# Facility: MLK Jr. Memorial at Battle Garden

Address: 800 W. Stadium Blvd. Date of Survey: 04/18/10

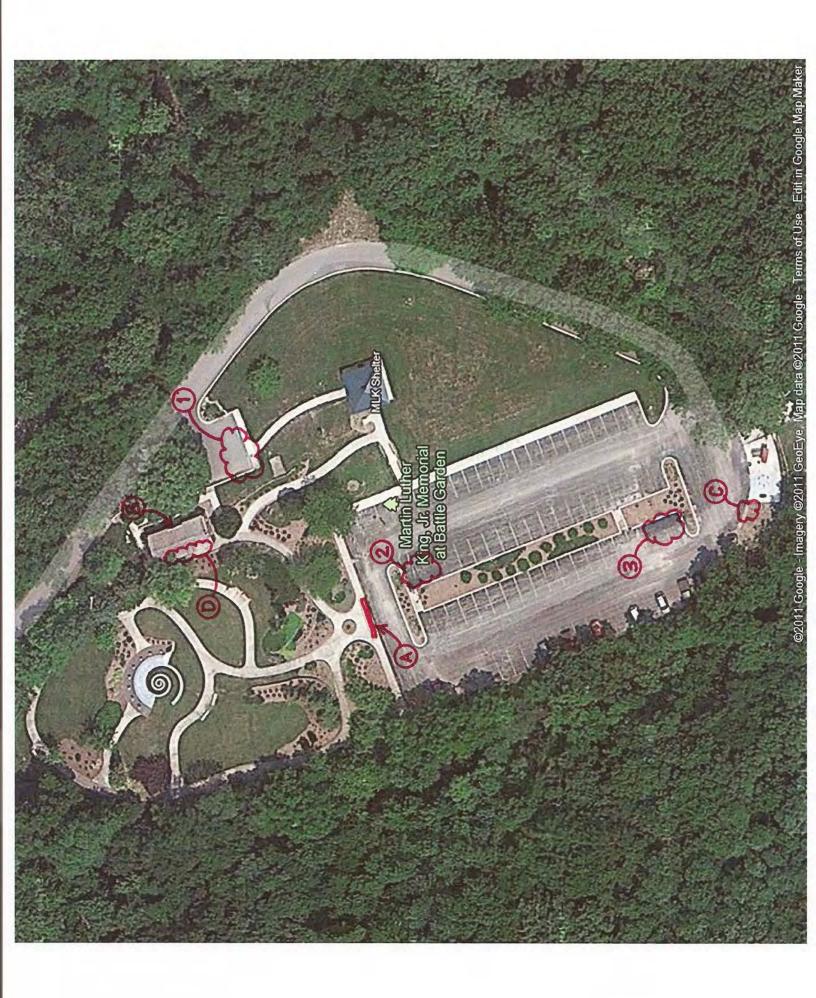
Refer to site plan included with this report: (1) Two ADA parking spaces in upper lot near the Audubon Society Museum have cross-slopes up to 4%. Repave the spaces for cross-slope not exceeding 2% and restripe.

Refer to site plan included with this report: (2) Two existing ADA parking spaces are sized properly, but the blue paint striping needs to be re-applied, the existing sign needs to be moved to one ADA space and mounted at 72" above grade and one new sign needs to be added at other ADA space.

Refer to site plan included with this report: (3) Two existing ADA parking spaces are sized properly, but the blue paint striping needs to be re-applied, the existing sign needs to be moved to one ADA space and mounted at 72" above grade and one new sign needs to be added at other ADA space.

Refer to site plan included with this report: (A) Install a minimum 3' deep strip of contrasting truncated dome detectable warning surface across the entire width of the sidewalk intersection with the parking lot (see photo 2 below).

Refer to site plan included with this report: (B) Install wall-mounted handrail on both sides of ramp (existing guardrail does not meet ADAAG 4.8.5 requirements for handrails – see photo 3 below). Handrails shall be 1.5" diameter, be continuous along the gripping surface and mounted between 34" & 38" above the ramp surface.
Estimated Cost: \$1,340.00

Refer to site plan included with this report: (B) Replace main entry door knob with lever hardware at the Columbia Audubon Society Trailside Museum Building.
 Estimated Cost: \$305.00

- Refer to site plan included with this report: (C) Replace the non-wheelchair accessible portable toilet unit located at the south end of the main parking lot near the MKT trail access point (cost unknown).

- Refer to site plan included with this report: (D) Men's Restroom in lower level of the Audubon Society Museum Building Install a braille/tactile ADA restroom sign at 60" a.f.f.at the latch side of the entry door, replace the non-accessible lavatory (see photo 4 next page) with an ADA compliant lavatory mounted no higher than 34" a.f.f. with minimum knee clearances meeting ADAAG 4.19, lower mirror to be no higher than 40" a.f.f. to bottom reflective edge, lower one urinal so that the front lip is no higher than 17" a.f.f., reconfigure the toilet stall to meet ADAAG Fig. 30 (b) 36" wide alternate stall (includes moving and/or lowering the toilet fixture as necessary) and modify shower to meet ADAAG 4.21 and Fig. 35 (b) (lower controls, install an additional fixed shower head at 48" a.f.f. and install proper grab bars).
  Estimated Cost: \$4,459.00

- Refer to site plan included with this report: (D) Women's Restroom in lower level of the Audubon Society Museum Building Install a braille/tactile ADA restroom sign at 60" a.f.f.at the latch side of the entry door, replace the non-accessible lavatory (see photo 4 next page) with an ADA compliant lavatory mounted no higher than 34" a.f.f. with minimum knee clearances meeting ADAAG 4.19, lower mirror to be no higher than 40" a.f.f. to bottom reflective edge, reconfigure the toilet stall to meet ADAAG Fig. 30 (b) 36" wide alternate stall (includes moving and/or lowering the toilet fixture as necessary and removing a minimum of 2" of the concrete masonry unit stall divider wall to allow for minimum of 42" access path to the toilet stall) and modify shower to meet ADAAG 4.21 and Fig. 35 (b) (lower controls, install an additional fixed shower head at 48" a.f.f. and install proper grab bars).
  Estimated Cost: \$4,059.00
